LONG'S WATER TECHNOLOGY
MAJOR PLAN 2021-106
ATTACHMENTS

TO: PLANNING COMMISSION
FROM: GREGG ADAMS, PLANNER
SUBJECT: LONG'S WATER TECHNOLOGY
MAJOR PLAN 2021-106
REQUEST FOR PRELIMINARY/FINAL PLAN REVIEW

SUBJECT: South Whitehall Township
Long's Water Technology, Inc.
1567 Hausman Road
Major Plan #2021-106
Preliminary/Final Land Development Plan Review

RE: Geotechnical Engineering Review of
Provided Documents
Long's Water Technology
Major Plan 2021-106
South Whitehall Township, Lehigh County,
Pennsylvania
Hanover Project SWT21-11(007)

SP-1
F.B. 269, PG. 61

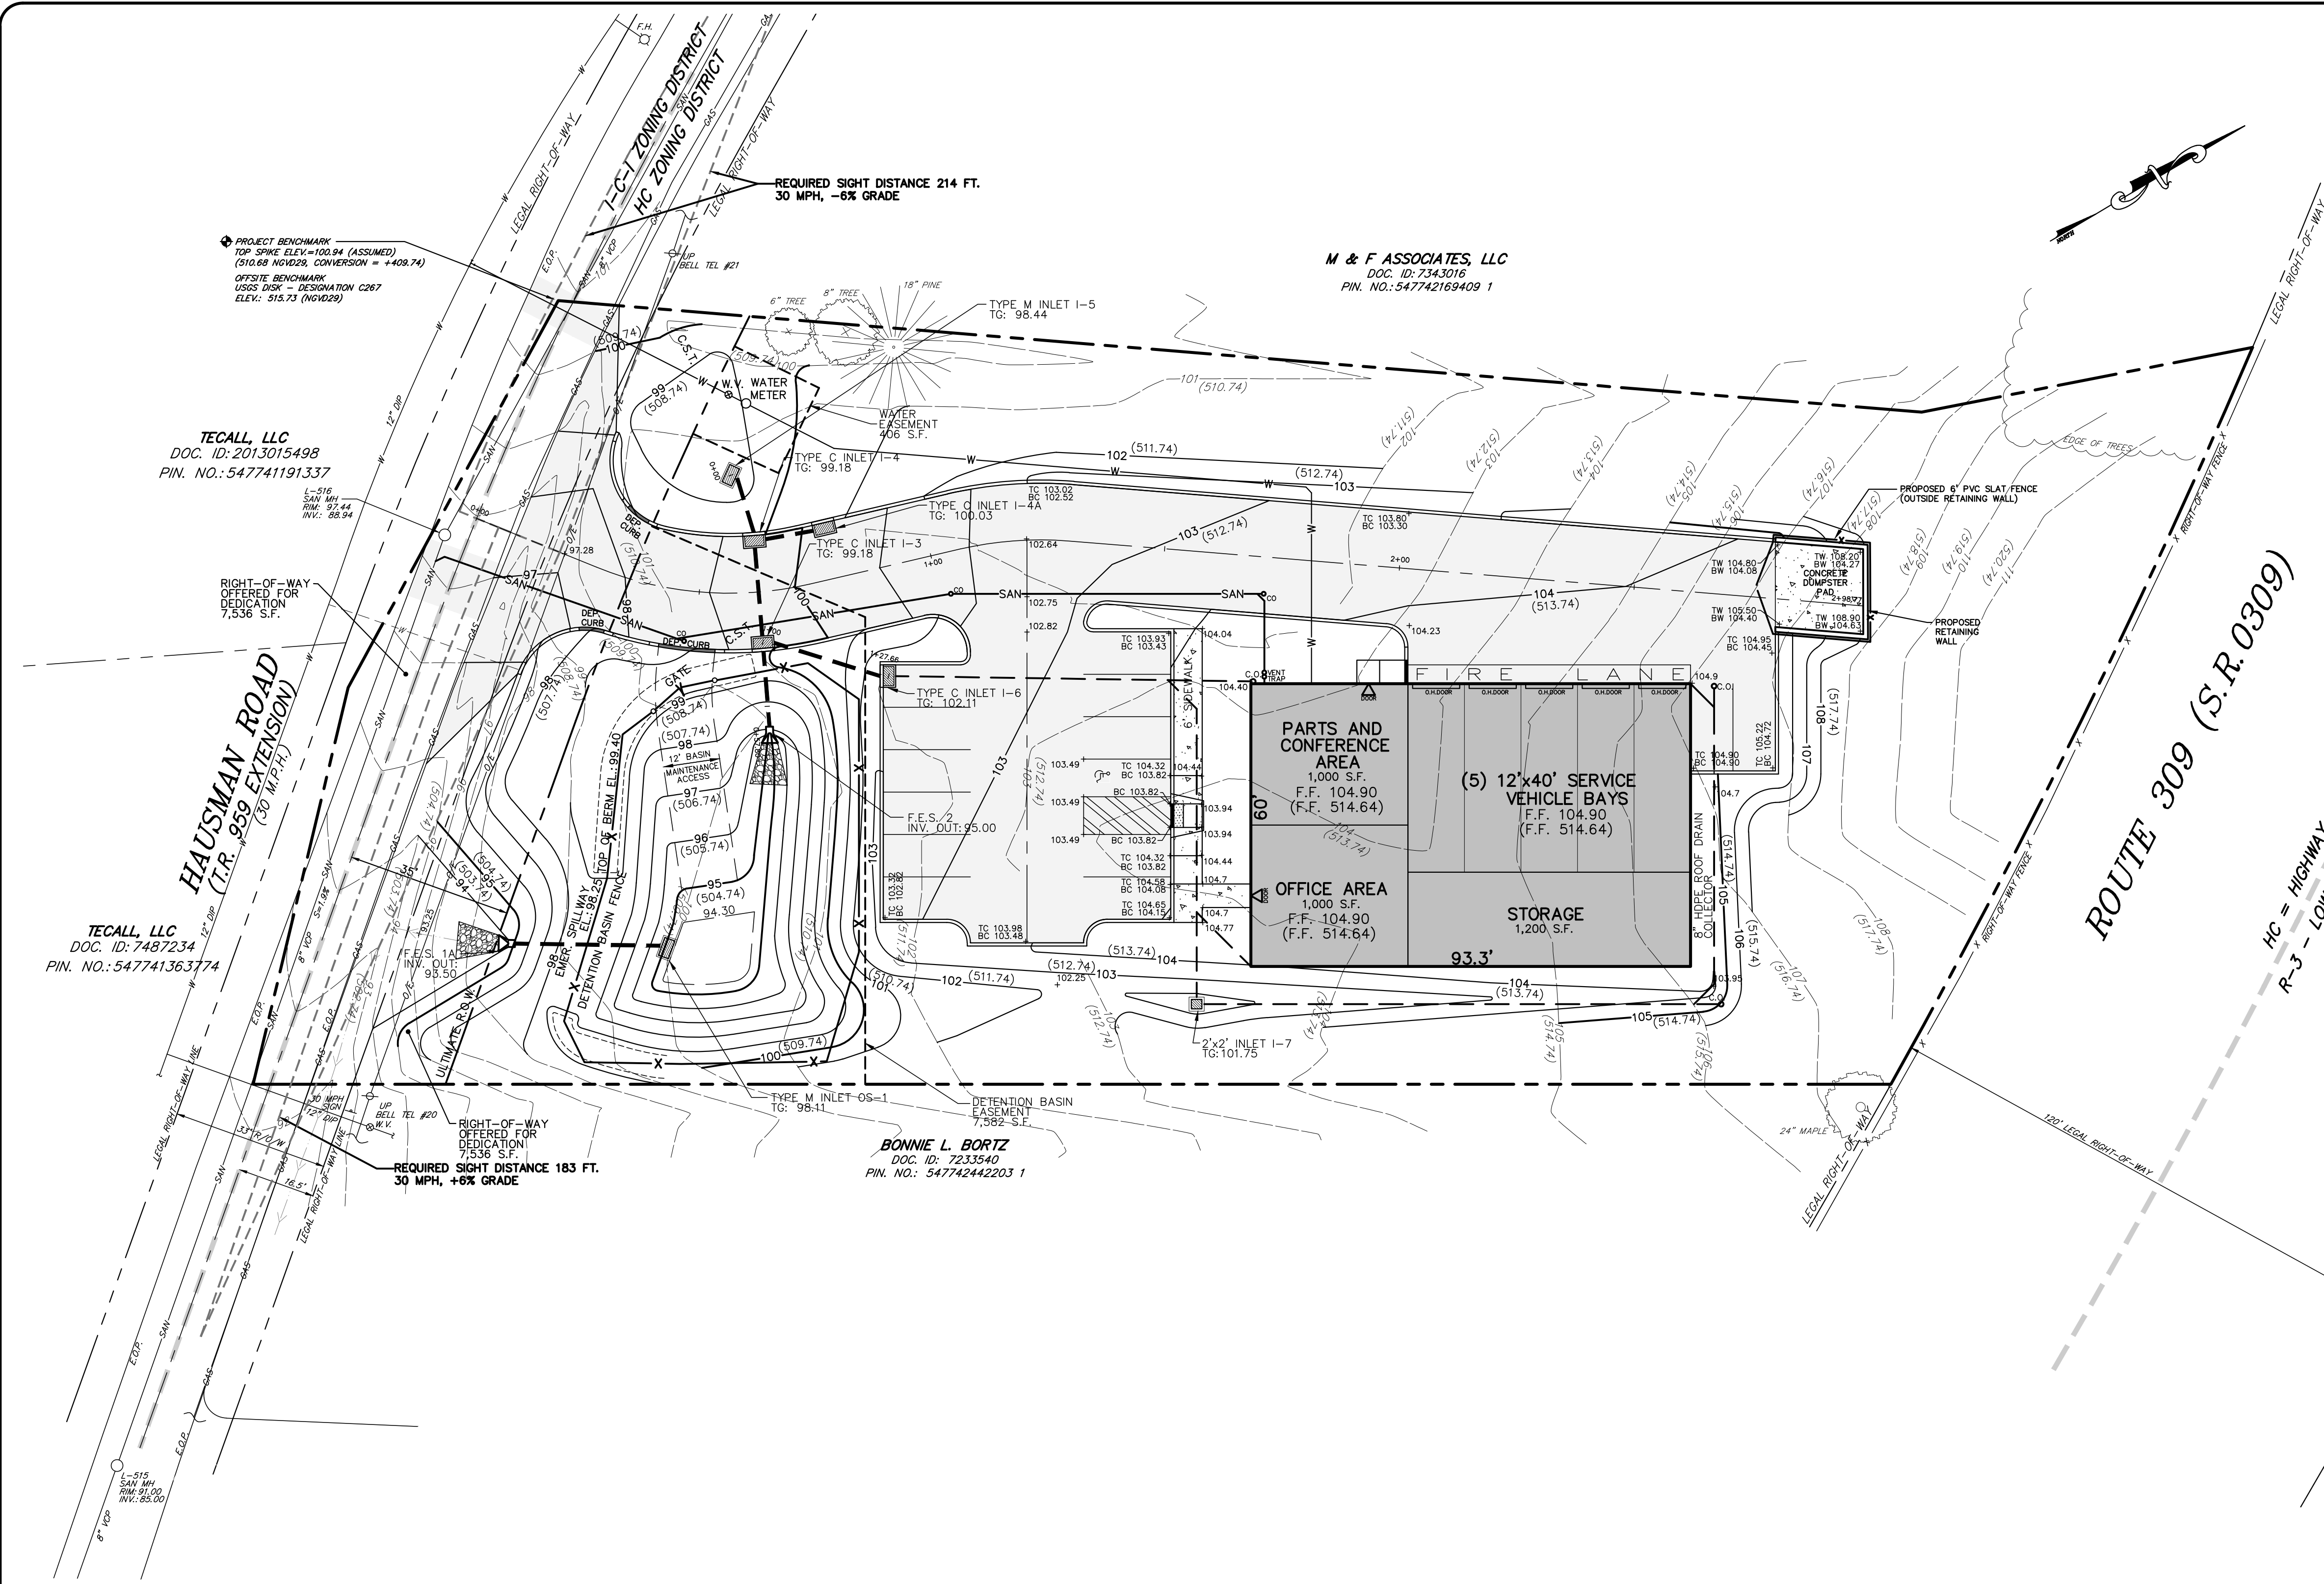
These relief requests are included in a Waiver/Deferral Note on Plan Sheet 1. In the event waivers/deferrals are granted, revise the Waiver/Deferral Note to include the dates of approval.

3. Provide security grates on FES-2 and FES-1A, SALDO §312-39(d)(5);
4. The Solicitor should determine if the Stormwater Facilities Access Note on Sheet 1 is acceptable and functions as a blanket stormwater easement. If individual easements are provided for stormwater management facilities, easements with metes and bounds should be provided for review;
5. The basin grading should be revised to provide a minimum slope of 2% along the bottom of the detention basin, SALDO §312-39(d)(2);
6. The BMP design and maintenance schedule should be included on a sheet to be recorded and in an agreement, SALDO §312-27(a)(4), SMP §296-18.D, and SMP §296-27 through 33;

COPYRIGHT 2021
 SHEET: 3 of 14
GP-1

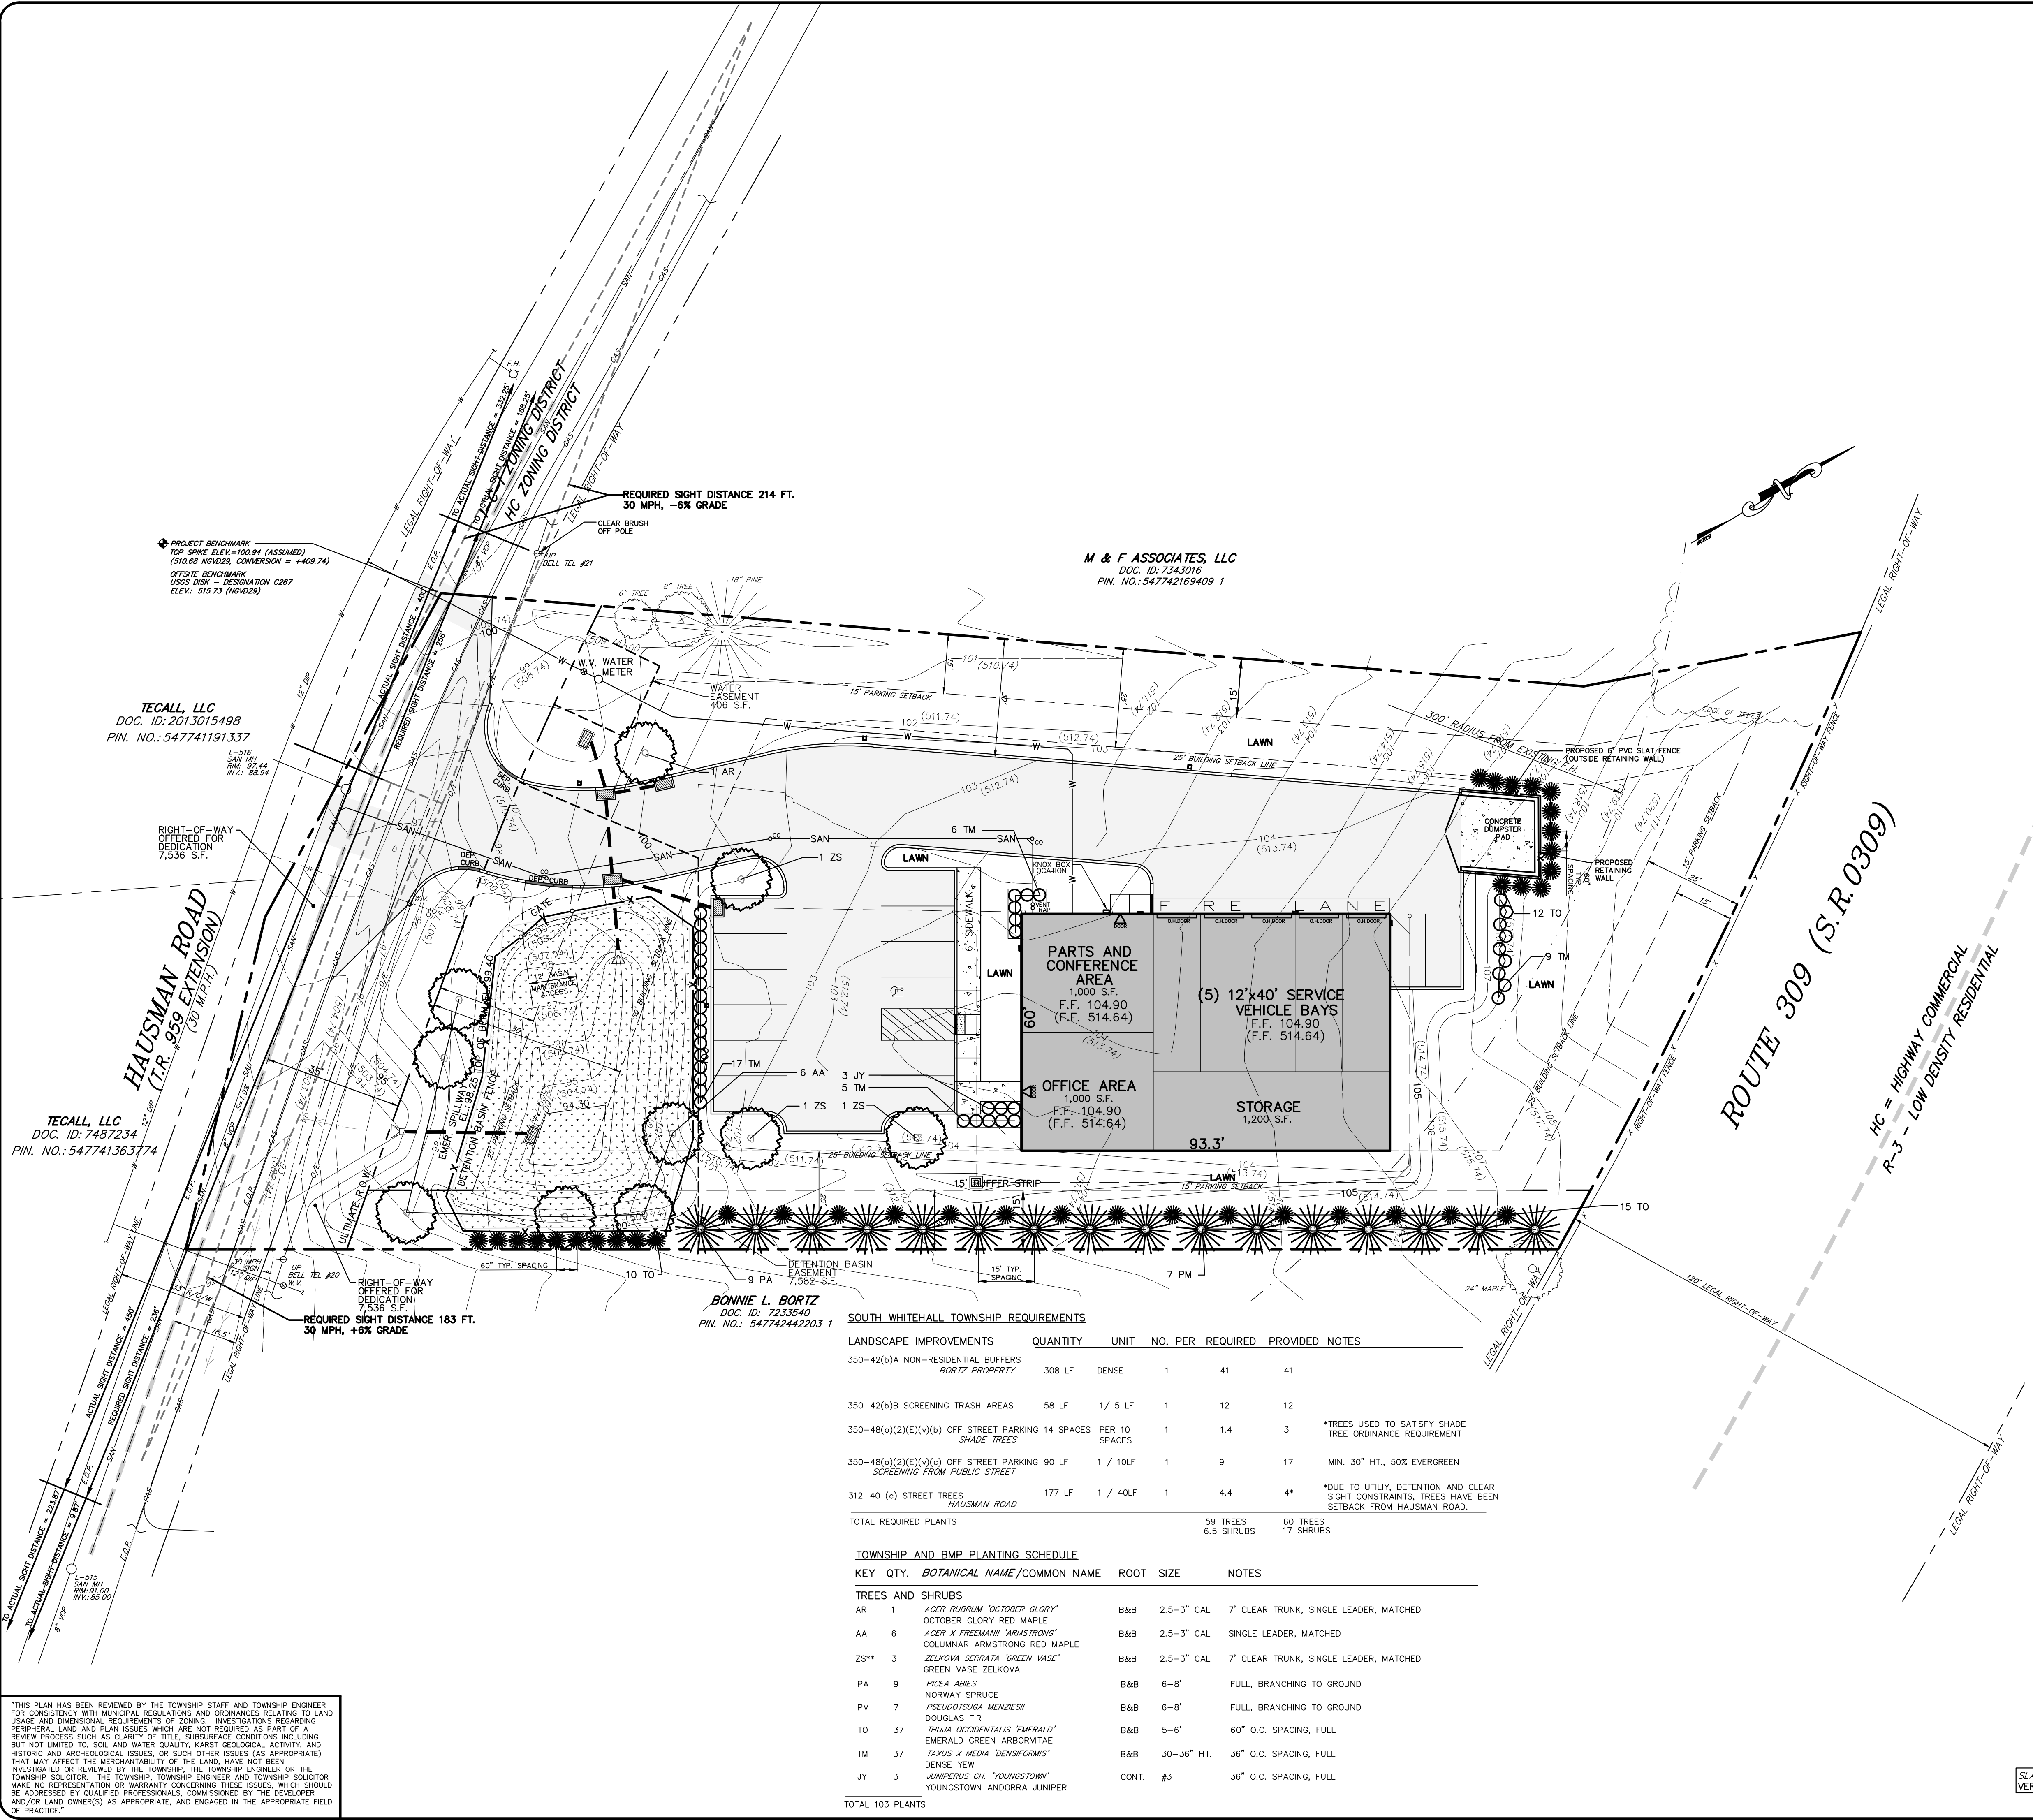
6. It is not clear that the proposed detention basin meets the requirement for a minimum longitudinal slope of two percent (2%) across the basin floor (SALDO 312-39.D.2).
7. A detail has been provided for the proposed retaining wall around the dumpster pad. The consultant shall provide wall design, specifications and details, signed by a Professional Engineer, to the Township for review and approval. This is required before a building permit for the wall is issued.
